MILPITAS PLANNING COMMISSION AGENDA REPORT

TITLE: 'S' ZONE APPROVAL AMENDMENT (SA2004-13)

Proposal: Request to install an 8-foot tall property fence along the rear and side portions of two adjacent properties in the Midtown zoning district.

Location: 244-250 & 260 South Main Street

SITE PLAN

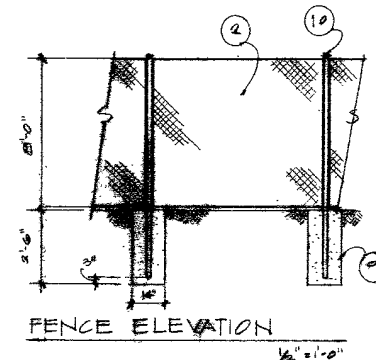
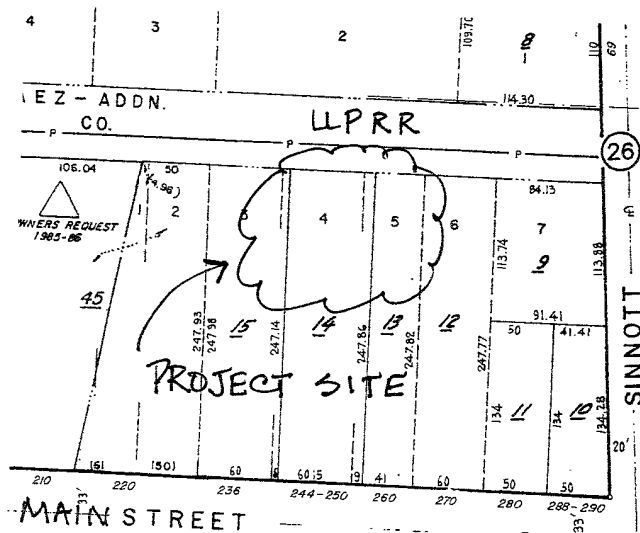
The plans submitted by the applicant indicate the proposed fence will be constructed of chain link fencing with no proposed slats. However, the property owner is requesting the fence be constructed of high quality, natural wood posts and planks to create a visually appealing and durable fence in keeping with the Midtown design guidelines. Prior to building permit issuance, the property owner has agreed to submit new plans detailing the proposed wood fence.

1. This 'S' Zone Approval-Amendment No. SA2004-13 is for the approval of an eight (8) foot tall fence, constructed of natural wood materials, and located as shown on approved plans dated May 12, 2004. (P)
2. Prior to building permit issuance, the applicant/property owner shall submit revised plans accurately showing all property lines (based on recorded information), existing buildings and structures on site, as well as detailed elevations of the proposed fence. The design of the wooden fence shall be to the satisfaction of the Planning Manager. (P)
